RADIOLOGIC AND ENGINEERING ASSESSMENT

DOE ID NO.: GJ-03635-RS
ADDRESS: 459 BELFORD AVENUE

JULY 1985

URANIUM MILL TAILINGS REMEDIAL ACTION PROJECT OFFICE

FIGURE 3.5

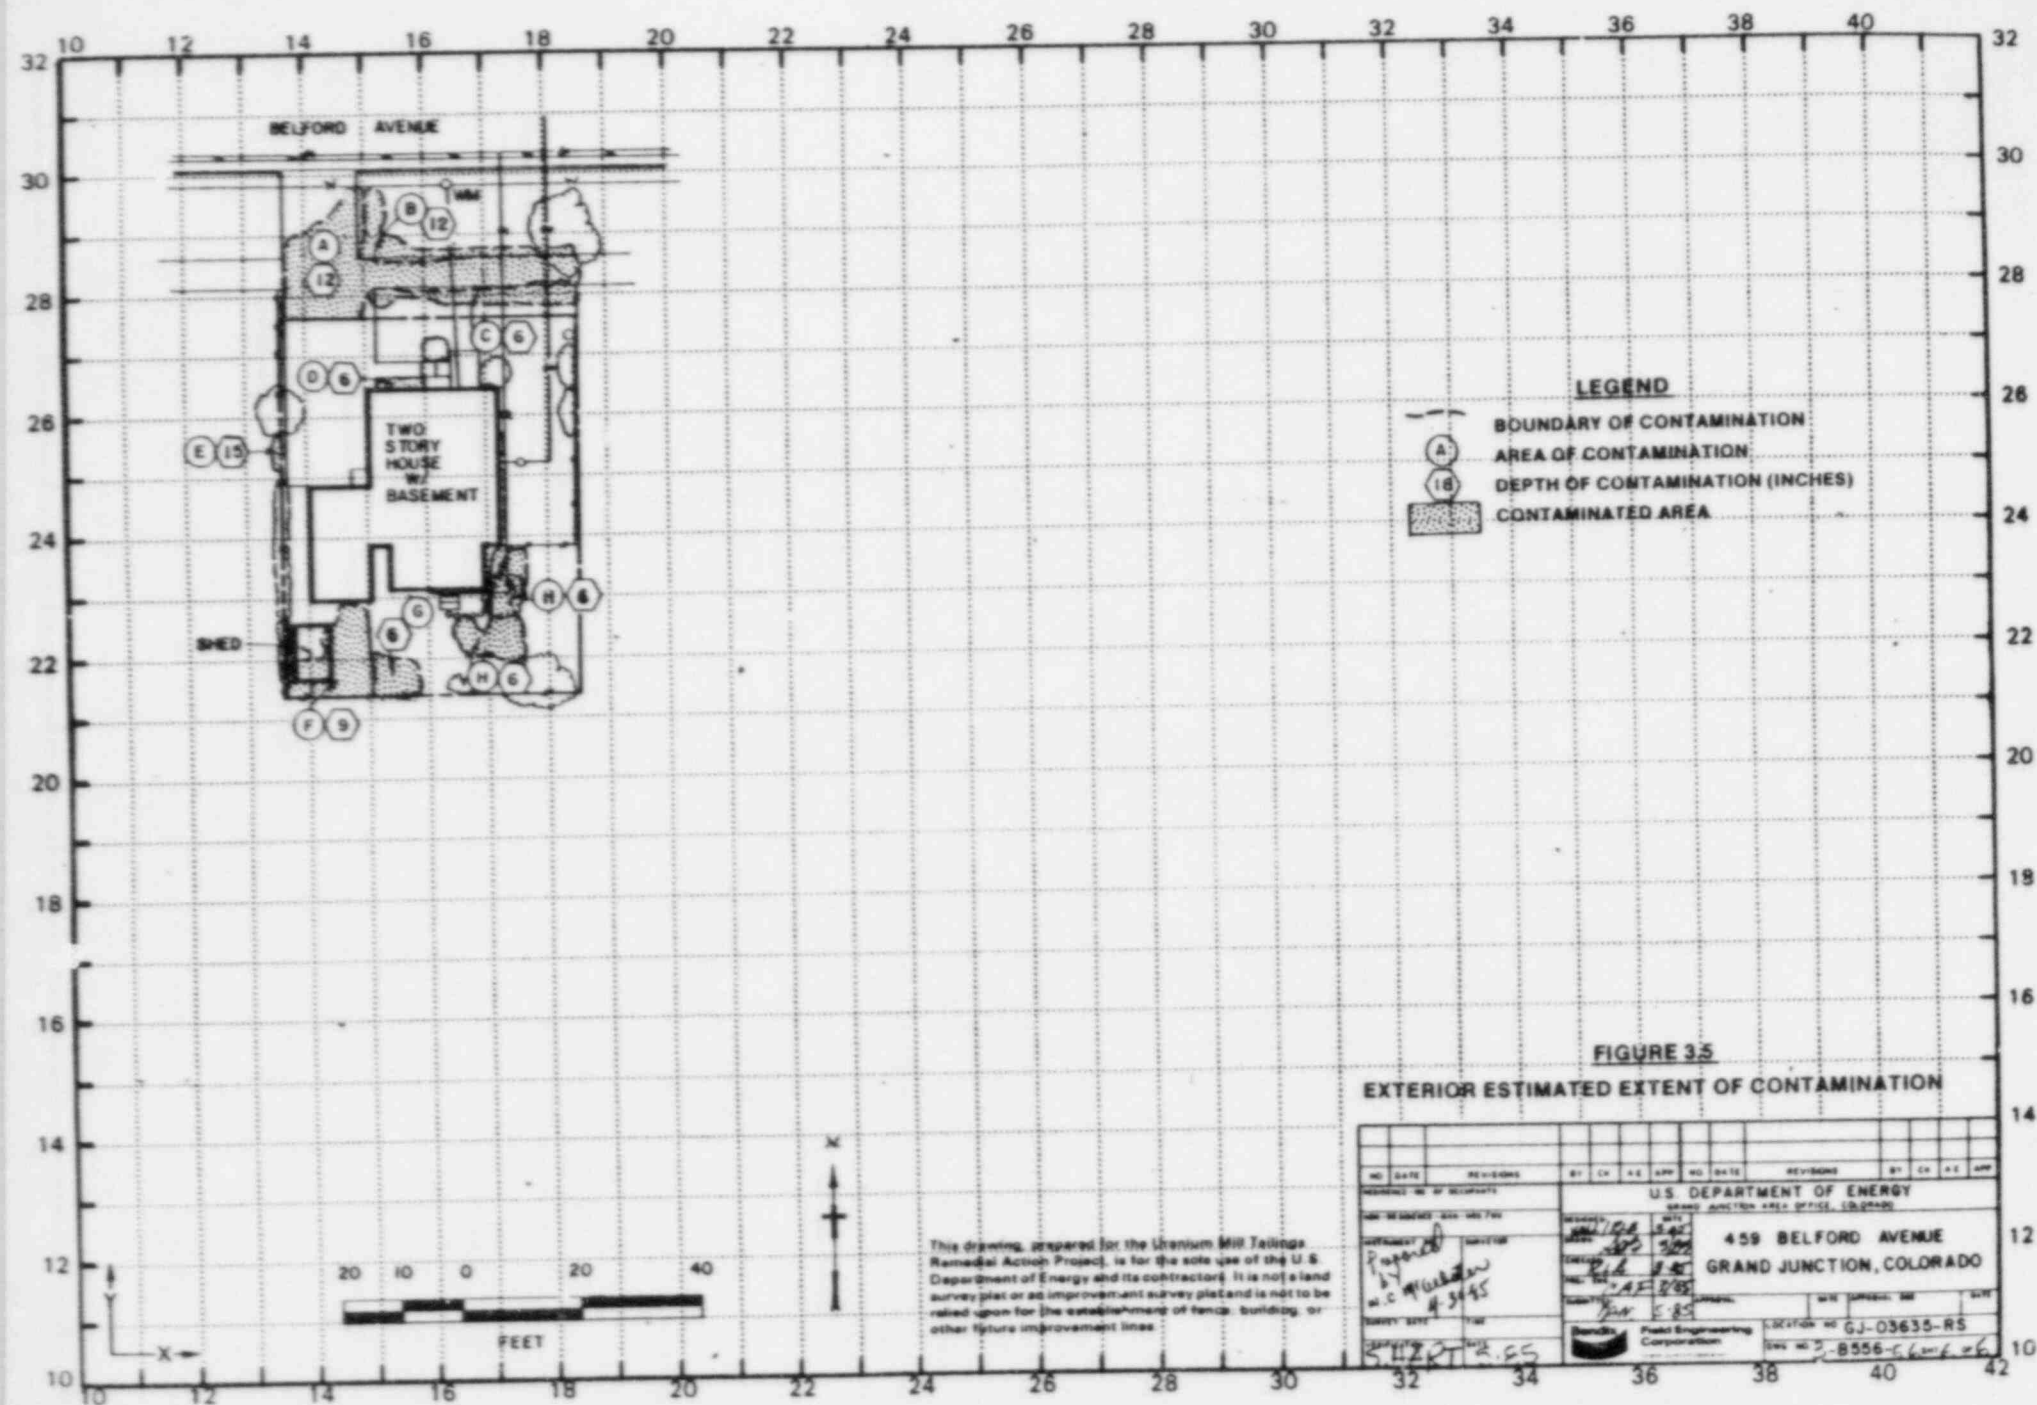
The following is in response to your questions and comments during the Technical Review concerning Department of Energy (DOE) Identification (ID) number GJ-03635-RS (459 Belford Avenue), conducted 19 April 1985.

1. A new area of contamination map has been made, Area 'C' was added where delta 19 (grid location 170280) was taken. Description for delta 19 (northwest corner of property) was an error.

2. A revisit was made on 22 April 1985. The north edge of the sidewalk was investigated and included in the new estimated extent of contamination map.
3. The section of the sidewalk that showed no contamination was reinvestigated and was determined to be contaminated to the same extent as the rest of the sidewalk. This area was not a different pour.

4. The shed area will be included as an area for further investigation during remedial action.
5. The area of contamination over the sewer line will be included as an area for further investigation during remedial action.

6. A more legible sample location map is included with this letter.
7. The contamination under the city sidewalk ends at the east and west end of the property lines.

Enclosed you will find a new copy of Figure 3.5 - Estimated Extent of Contamination, Figure 3.4 - Exterior Sample Locations, and an updated Table 3.1 - Radium Concentrations at Exterior Locations.
